COA # 2011-COA-185 (WD)	INDIANAPOLIS HISTORIC PRESERVATION COMMISSION STAFF REPORT	Hearing Date JULY 6, 2011
255 S. Meridian Street WHOLESALE DISTRICT		New Case
Applicant TODD TEMPERLY – TEMPERLY COMMERCIAL CONSTRUCTION, INC. Mailing address: 2068 Berry Road Greenwood, IN 40143		<i>Center Twp.</i> <i>Council District 19</i> <i>Dane Mahern</i>
Owner: Bruce Pallman 255 S. Meridian Street Indianapolis, IN 46225		
CASE		
IHPC COA: 2011-COA-185 (WD)	Removal of front façade upper story double-hung sash and transoms, replacement with fixed sash and internal grid design; recover three awnings with new canvas; remove existing aluminum storefront and door, replace with new to match existing.	
STAFF RECOMMENDATION: Approval of storefront, door and awning work; Denial of second story window proposal		
STAFF COMMENTS

2011-COA-185 (WD):

WINDOW ELEVATIONS - SCALE: 1/2" = 1'-0"

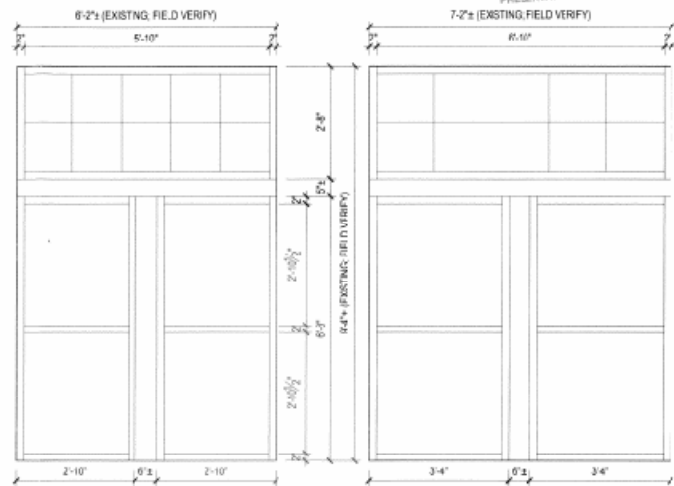
- Replacement of second story front façade double-hung wood sash with fixed aluminum.**
The Wholesale District Plan states, “Do not change the original shape, size, dimensions, design, and pattern created by the windows.” The windows as proposed change the depth dimensions, the design and the pattern of the existing wood windows. They will not be operational and will therefore look like a fixed sash when the openings have always had operable sash.

- Removal of divided light transoms and replacement with internal grid design.**
The Wholesale District Plan states that the dimensions, design and pattern of the historic design should not be changed if new window units are installed. An internal grid design does not have the same dimensions as a divided light unit, it is very flat and lacks the depth of external members.

- Wrapping perimeter frames with metal.**
“If total replacement is necessary, similar materials should be used.” Aluminum is not a similar material to the original wood. Wrapping the wood frames with aluminum changes the appearance of the trim as a whole.
